**County of Loudoun**

**MEMORANDUM**

**SUBJECT:** April 9, 2007 Planning Commission Worksession:  
SPEX 2006-0022 - Western High School at Fields Farm

**To:** Loudoun County Planning Commission  
**From:** Loudoun County Public Schools  
**Date:** April 2, 2007  
**Re:** **Western Loudoun High School at Fields Farm (SPEX 2006-0022)**  
**Additional Information in Response to the Commission's and Public**  
**Comment Questions for the Committee of the Whole April 9, 2007**  
**Work Session**

Three figures also follow (Figures 4, 5 & 6). These figures were submitted previously to the Town of Purcellville in response to their comments. Figure 4 illustrates all of the recommended improvements, Figure 5 illustrates those improvements warranted by

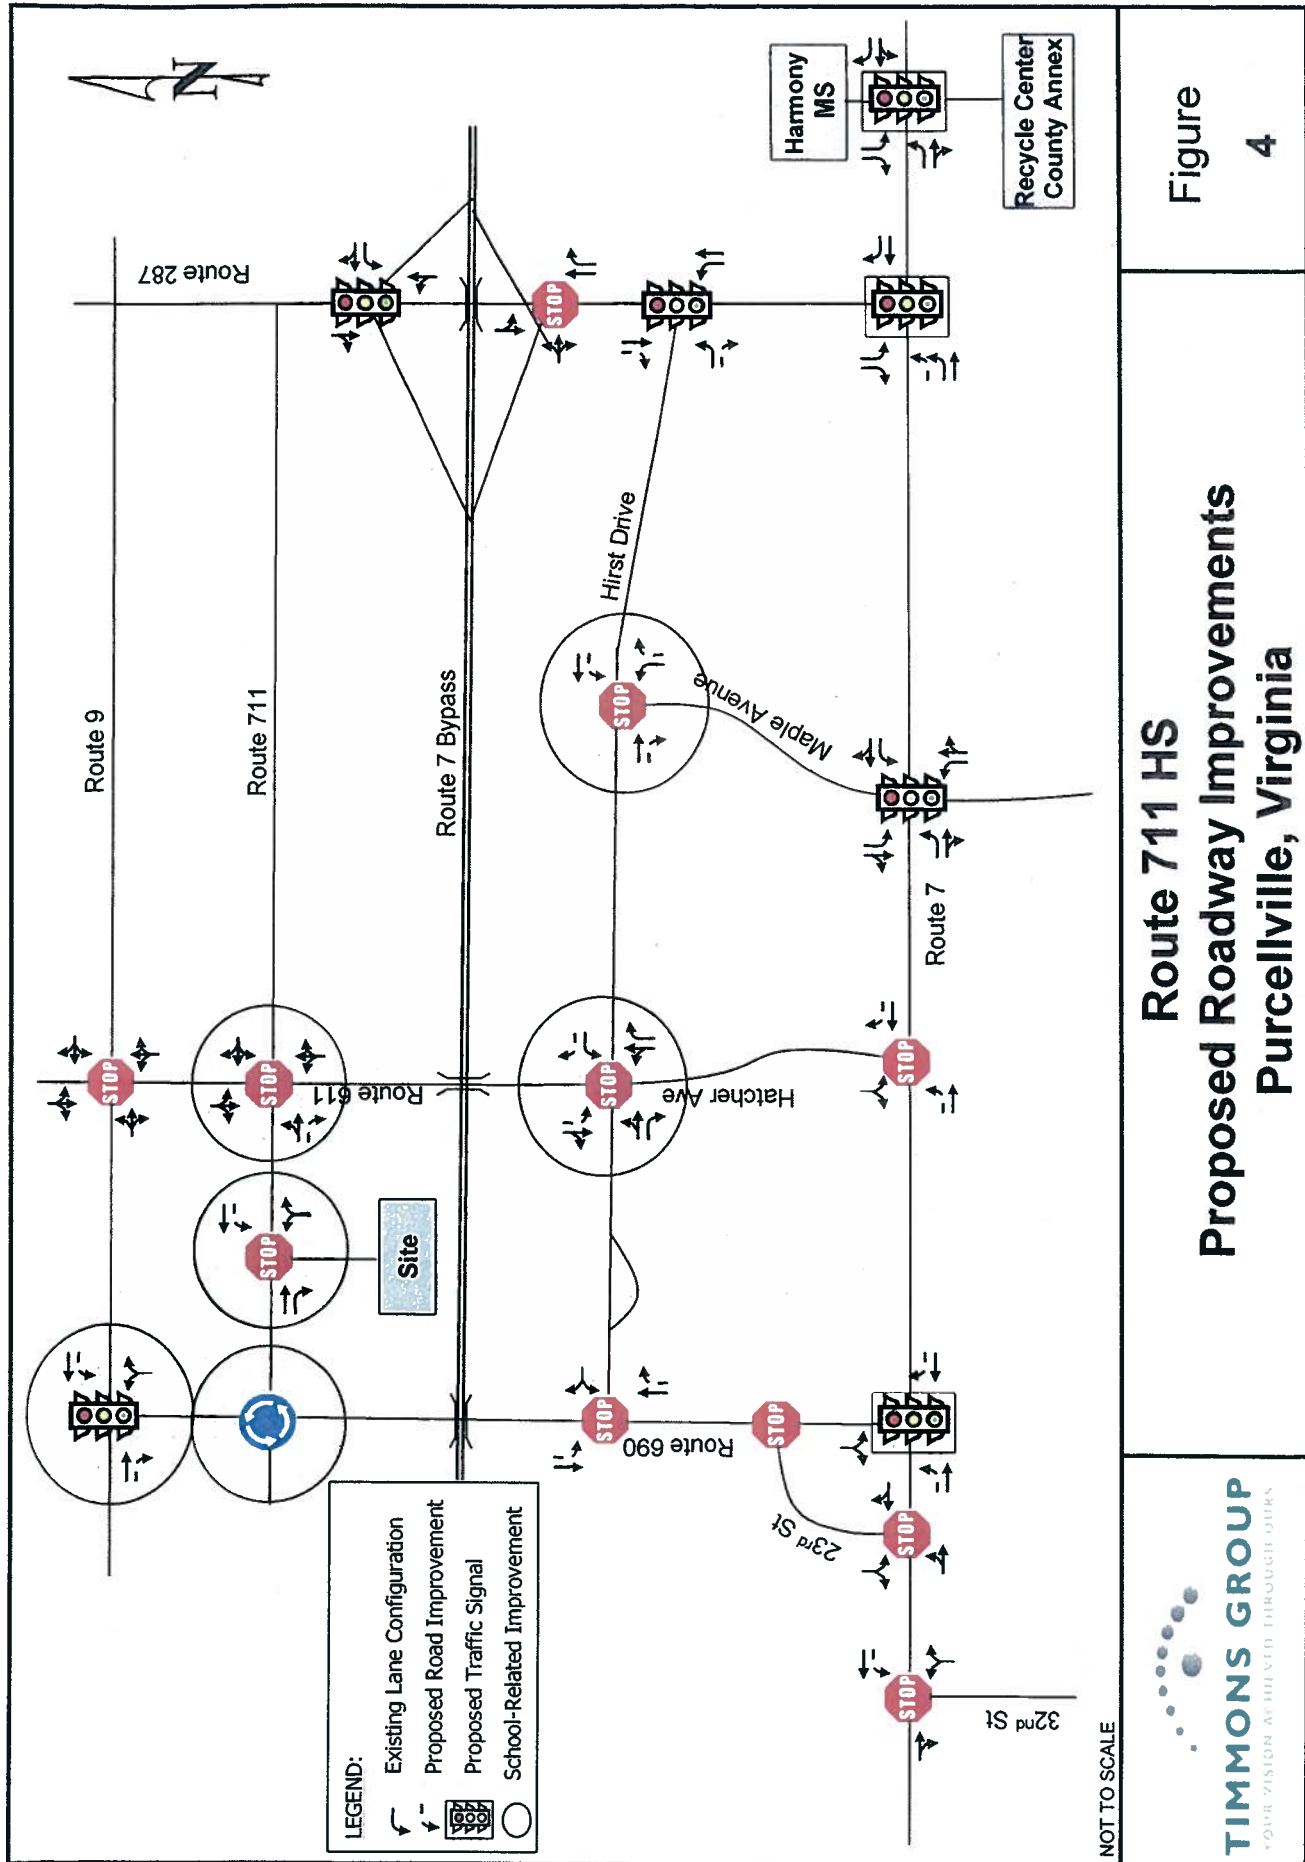
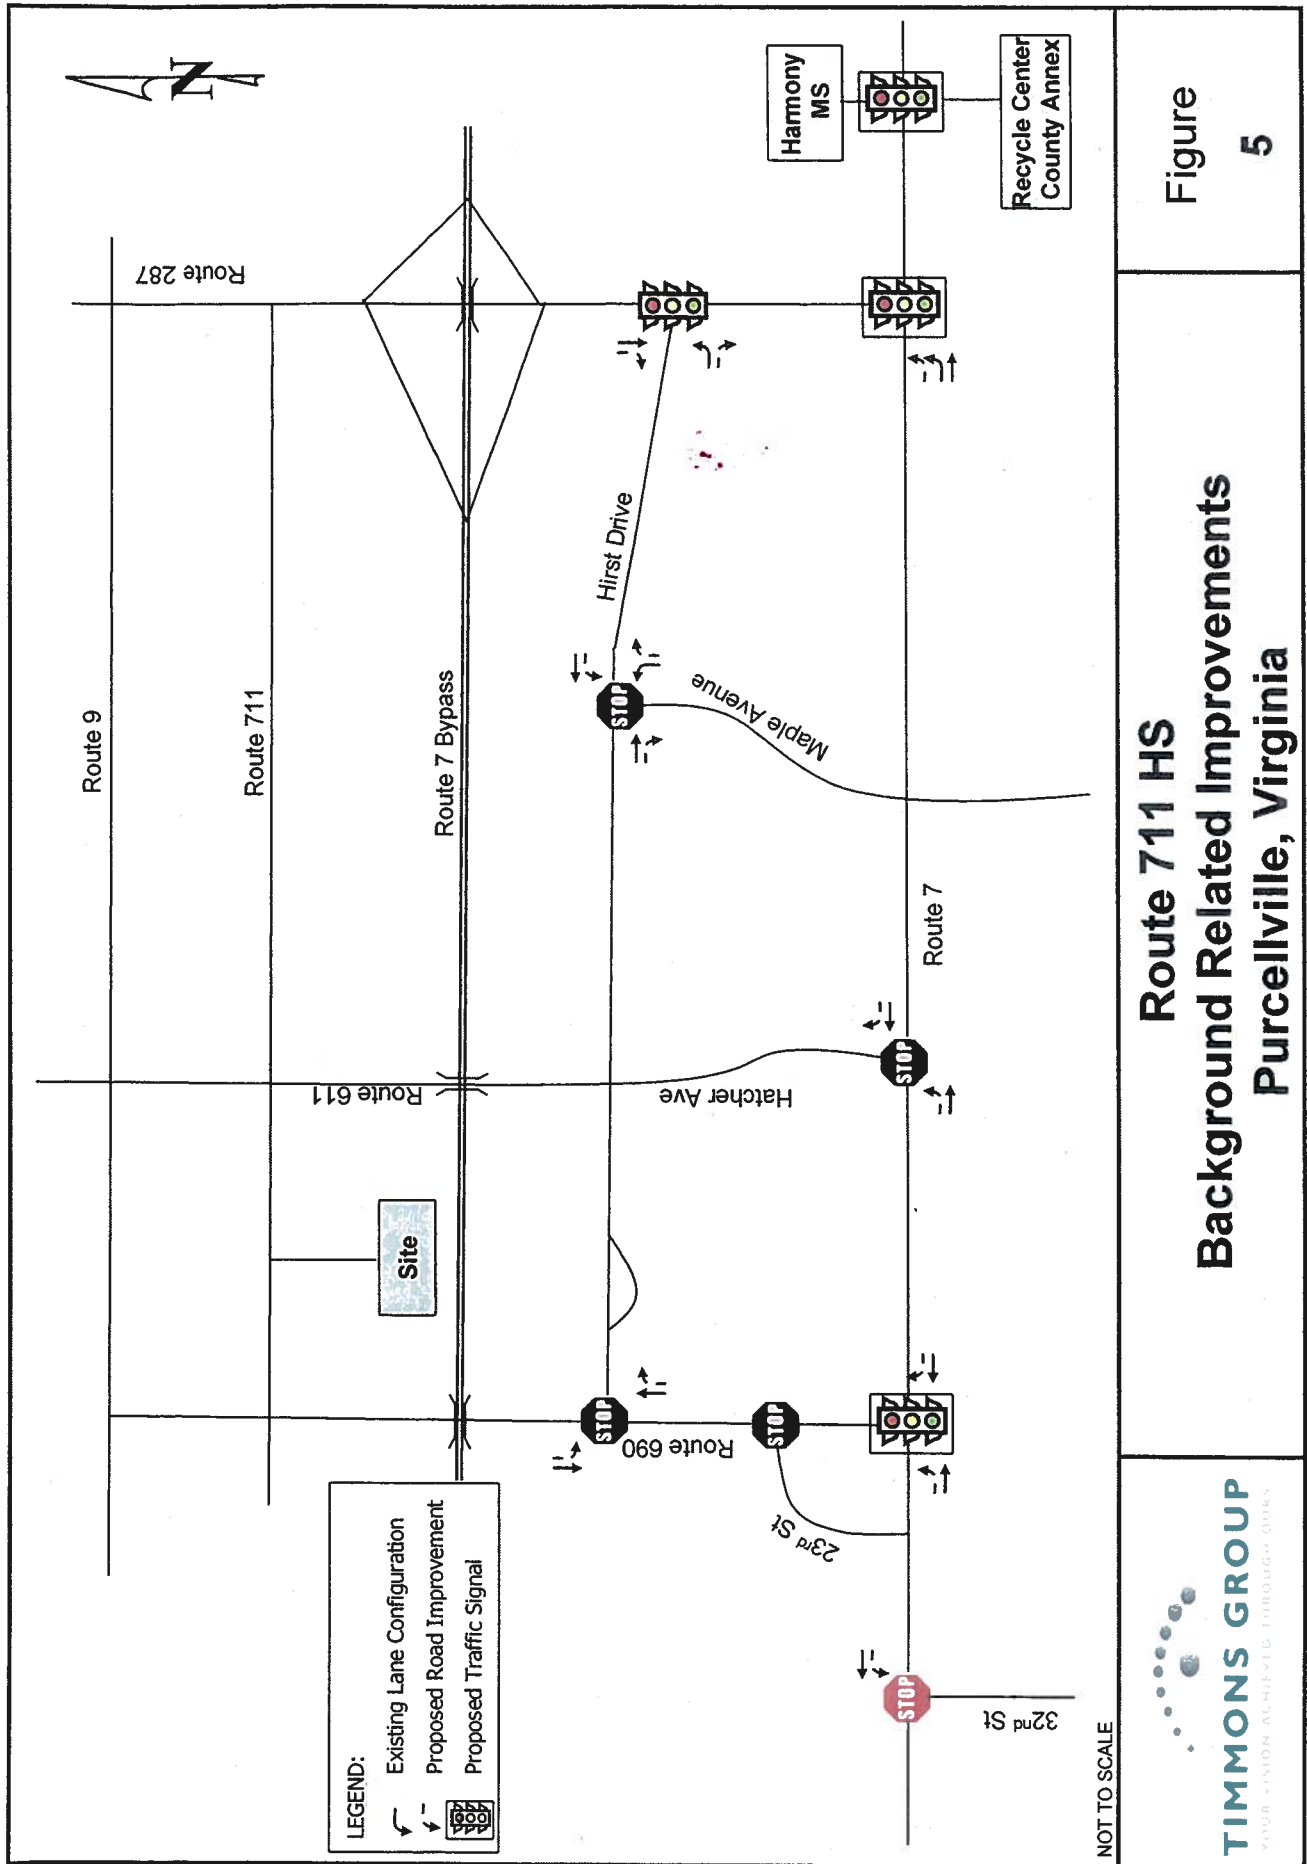
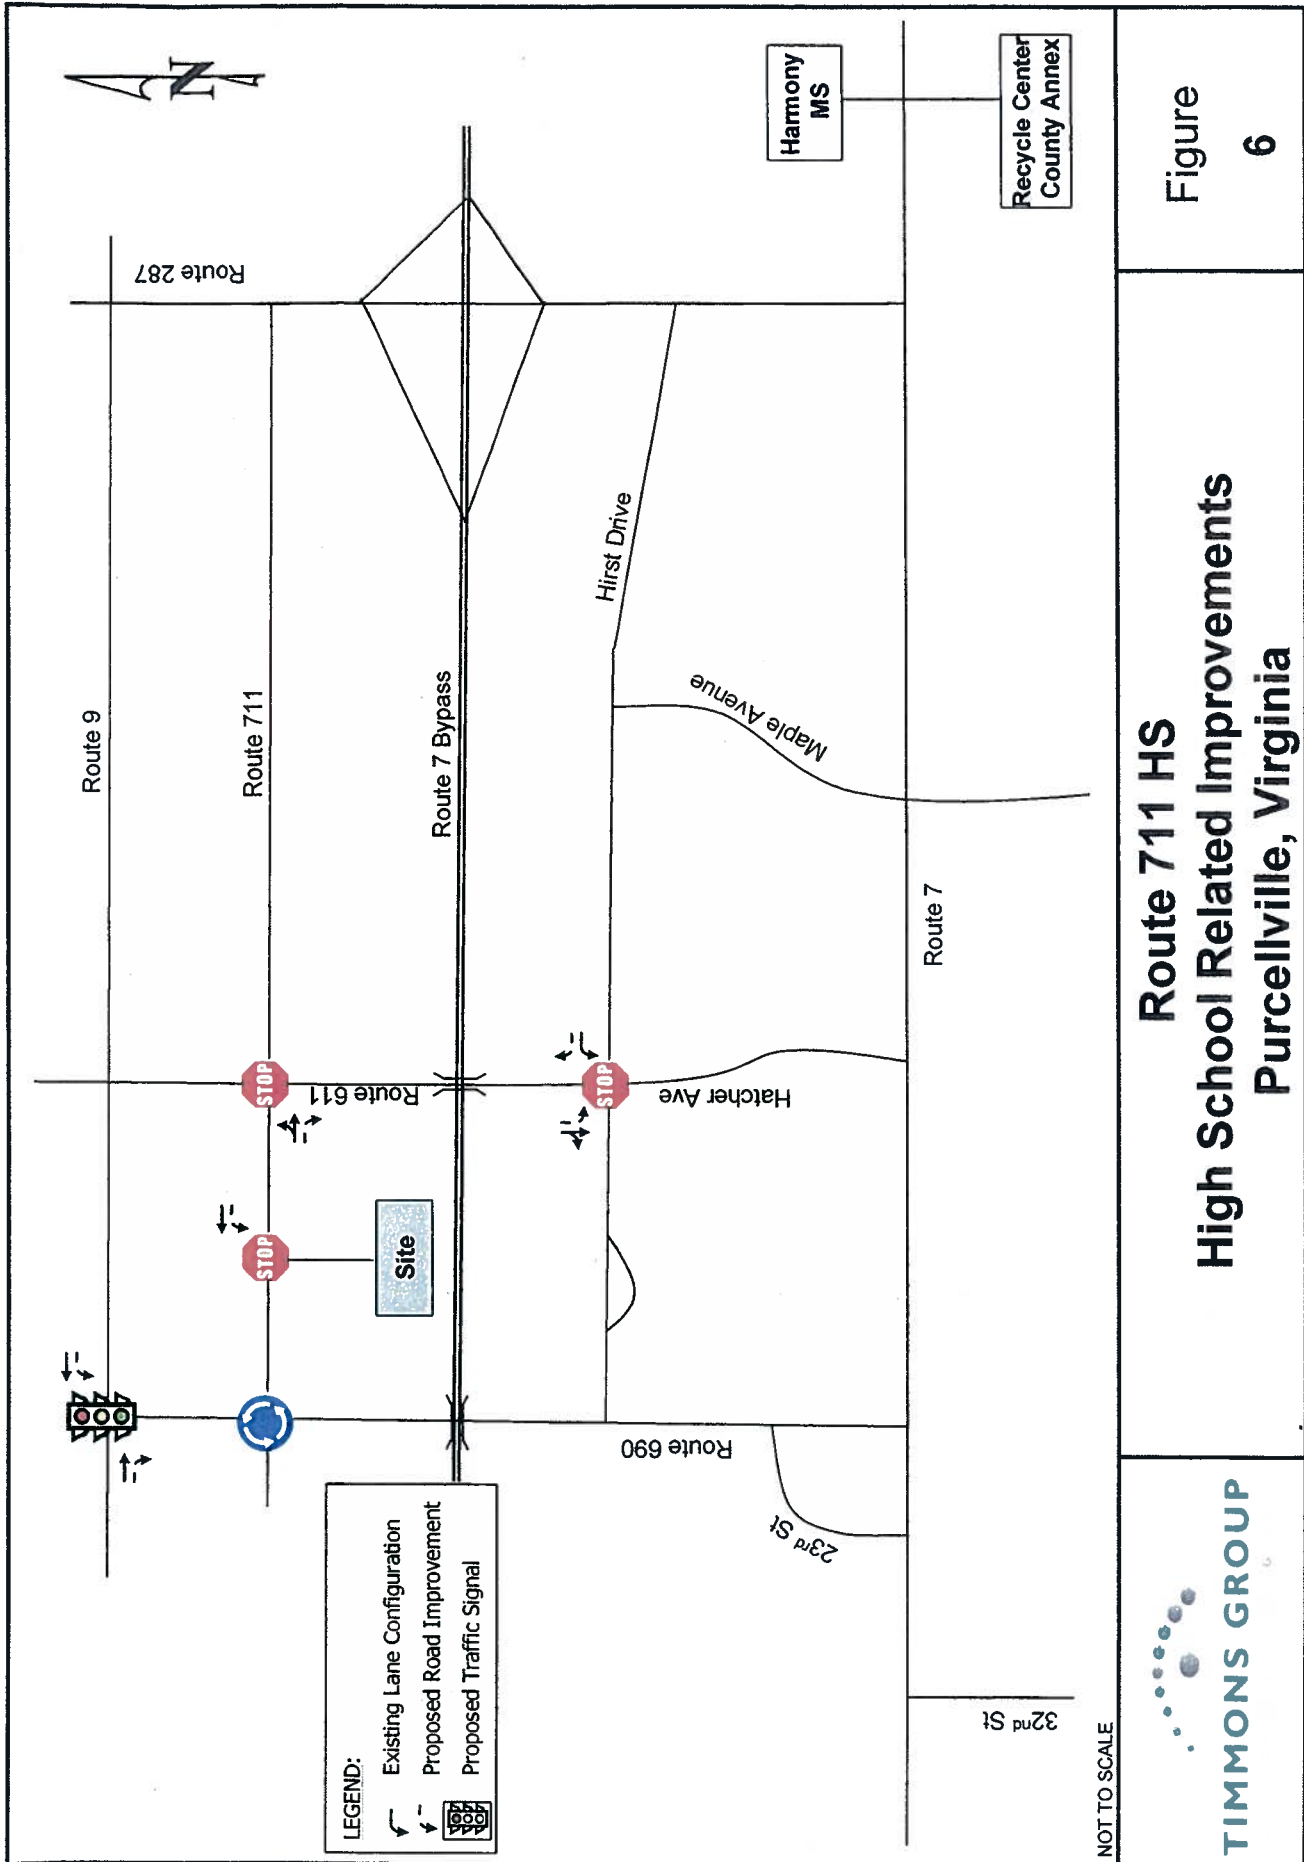
**Question: Provide a map and list of the road improvements proposed and the cost of same. The request was also made as to how much of these costs LCPS would be paying.**

background traffic, and Figure 6 illustrates those improvements warranted by school-related traffic.

### OPERATING LEVELS OF PUMPS

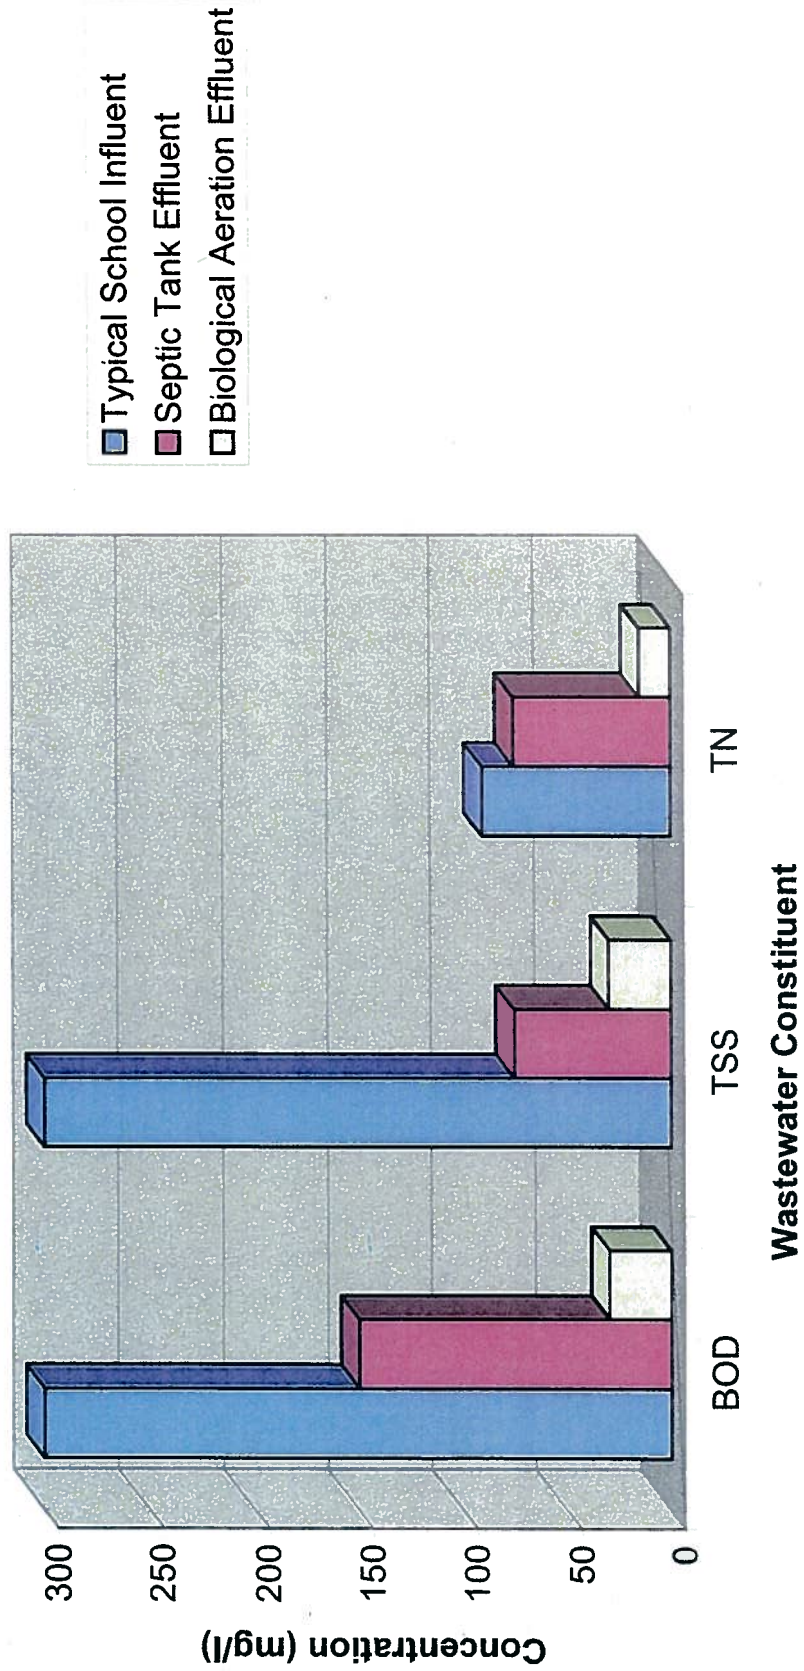
**Question: Describe in detail the wastewater system components.**

Under the proposed system, the wastewater produced from the school will be collected by a gravity collection system to an influent pump station. The flow from the high school football stadium will be collected by a separate gravity collection system to its own packaged pump station. Flow from this pump station will be pumped into a gravity manhole that immediately precedes the influent pump station. From the influent pump station, the wastewater will be transferred to a pre-treatment system consisting of a flow equalization tank and an Intermittent Cycle Extended Aeration (ICEAS) system. From the pre-treatment system, the effluent will flow to the drainfield dosing tanks where the wastewater will be pumped to a drip irrigation disposal field. The primary drip irrigation absorption field is approximately 3.5 acres. Approximately 3.5 acres of reserve area shall also be provided. The hydraulic profile is included as Attachment 1.
